**NOTICE OF A REGULAR MEETING
BONDURANT PLANNING AND ZONING COMMISSION
AUGUST 11, 2022**

**BUSINESS OF THE PLANNING AND ZONING COMMISSION
BONDURANT, IOWA
AGENDA STATEMENT**

TITLE: -RESOLUTION NO. PZ-220811-23: Considering recommended approval of the site plan at 3410 Henry Street SW

PUD MASTER PLAN 8-5-22

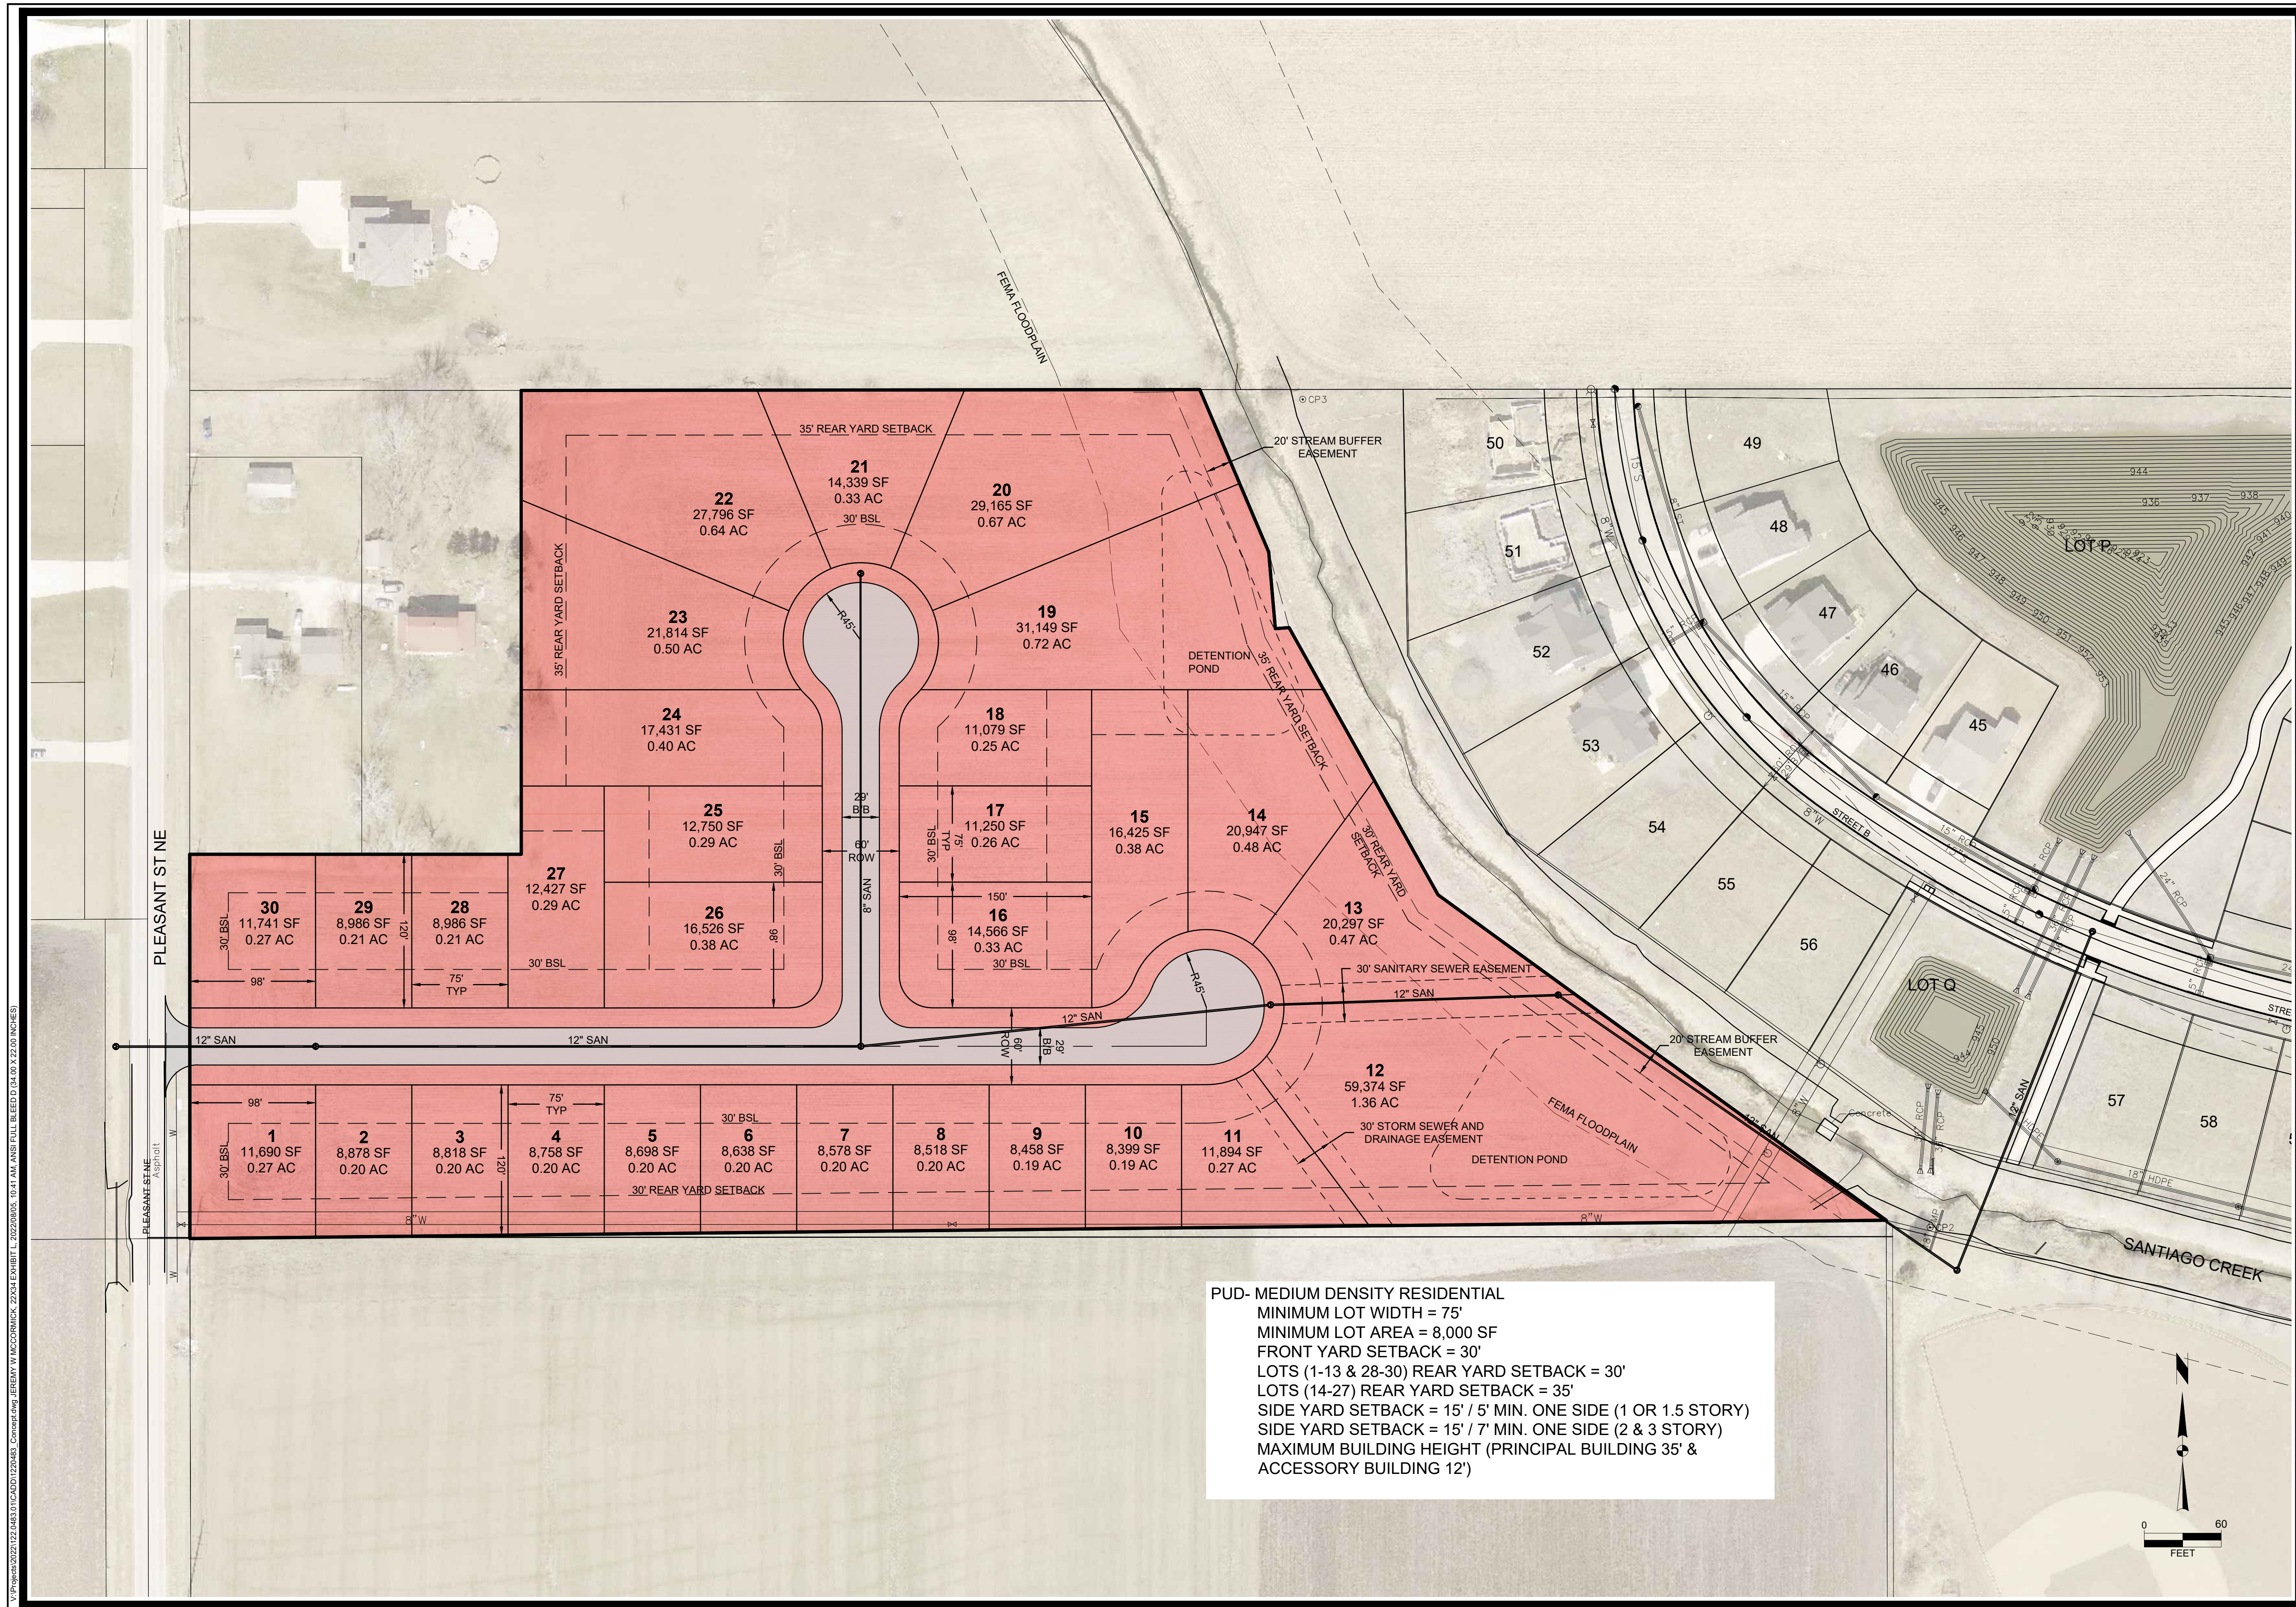
Does this approach to rezone from A-1 to R-5 instead of A-1 to R-2 seem acceptable? The Planning & Zoning Commission and City Council generally do not view planned unit development requests favorably where the sole purpose of the request is to skirt traditional R-1 or R-2 District standards. However, does this site have unique characteristics to justify reducing the rear yard setback on certain lots? Does the Commission feel any of the following rezoning conditions should be included as part of the rezoning ordinance so as to ensure the intent of the R-5 District is upheld?

- Should the PUD Conceptual Plan be updated to take into account how residents of this Park Side Estates neighborhood will access the adjacent BRSC/Lake Petocka area by the developer establishing a trail along the sanitary sewer and stream buffer easement areas? In FY24 the City of Bondurant has plans to establish a trail connection linking the Park Side and Featherstone neighborhoods to BRSC/Lake Petocka via a paved trail connection over Santiago Creek in the area shown in blue below.

- Should the PUD Conceptual Plan be updated to take into account any landscaping requirements along the south property line adjacent to the BRSC?
- Should the PUD Conceptual Plan be updated to note that basements will be required?

DIMENSION AND UTILITY PLAN

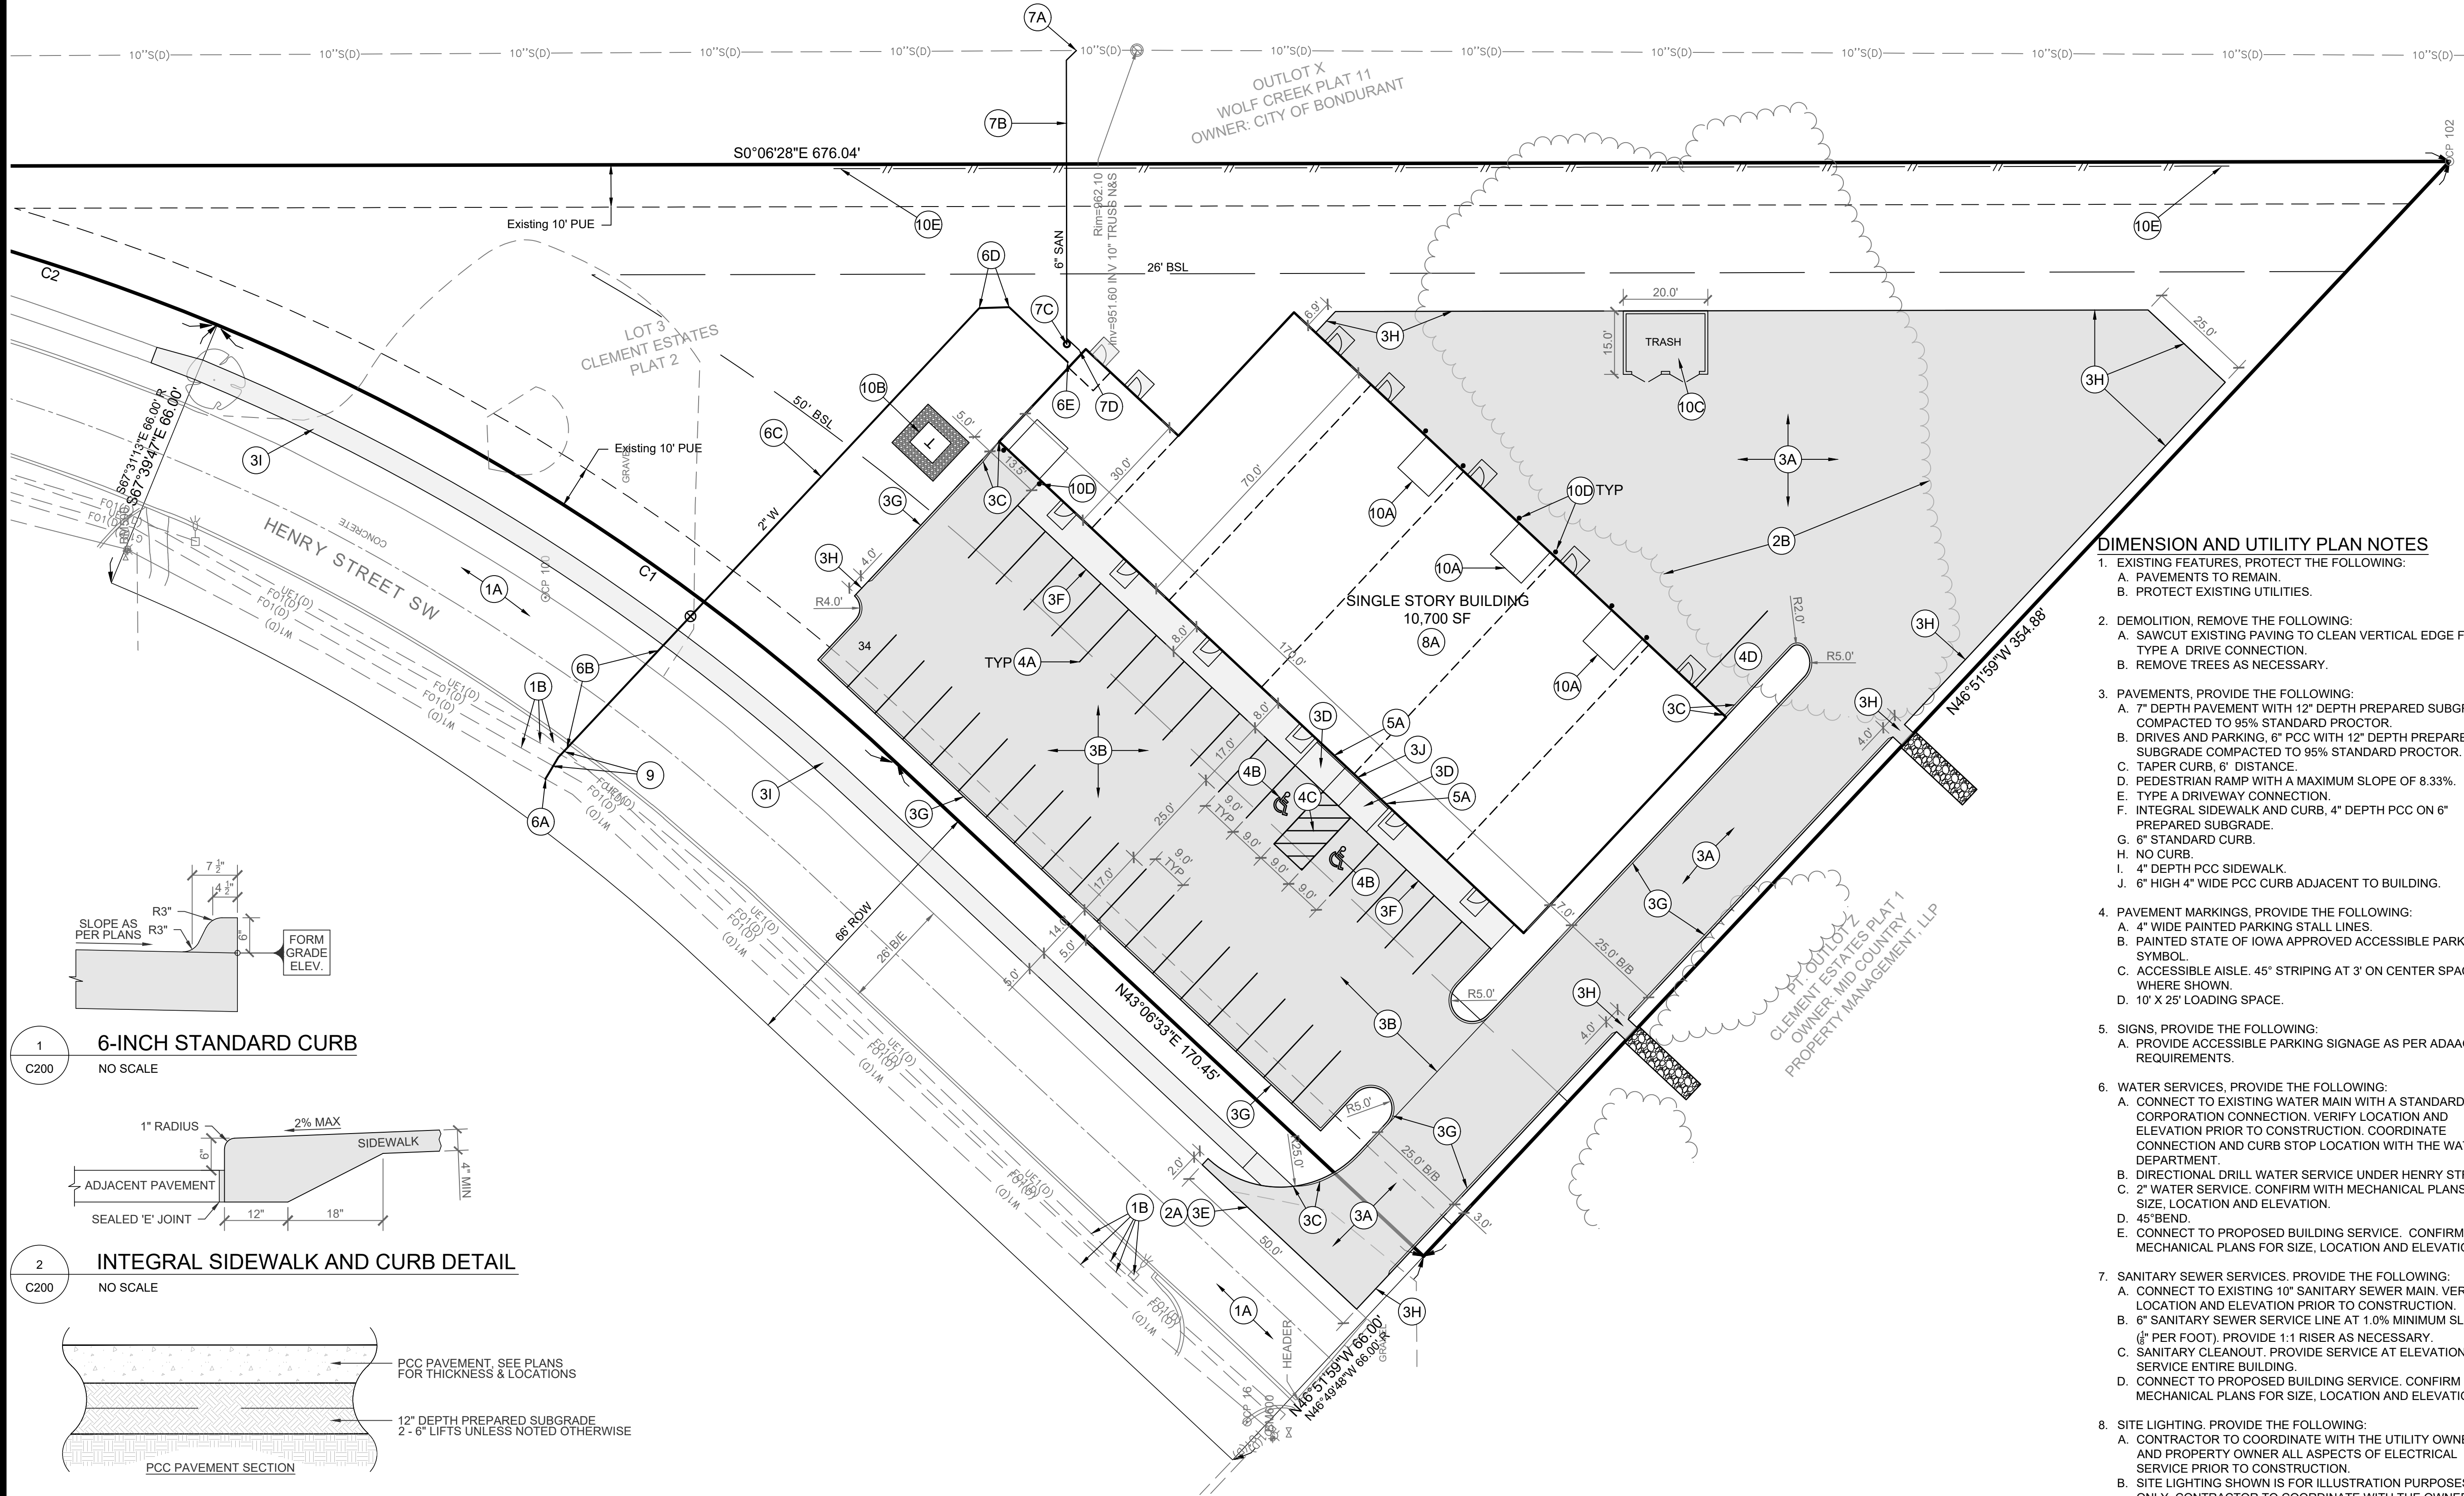
- Sheet C200 contains the required utility plan. Sanitary sewer service is shown by a service extending easterly to the City's sanitary sewer. A portion of the service is located off of the property. The service is located in Outlot X of Wolf Creek Plat 11 owned by the City of Bondurant. A 2" water service is shown to connect to the existing water main along the westerly side of Henry Street SW.
- This property is located within the Wolf Creek Sanitary Sewer Connection Fee District.
- This site is not situated within FEMA's 100-year floodplain.
- This site is not situated within the City's Stream Buffer Ordinance area.
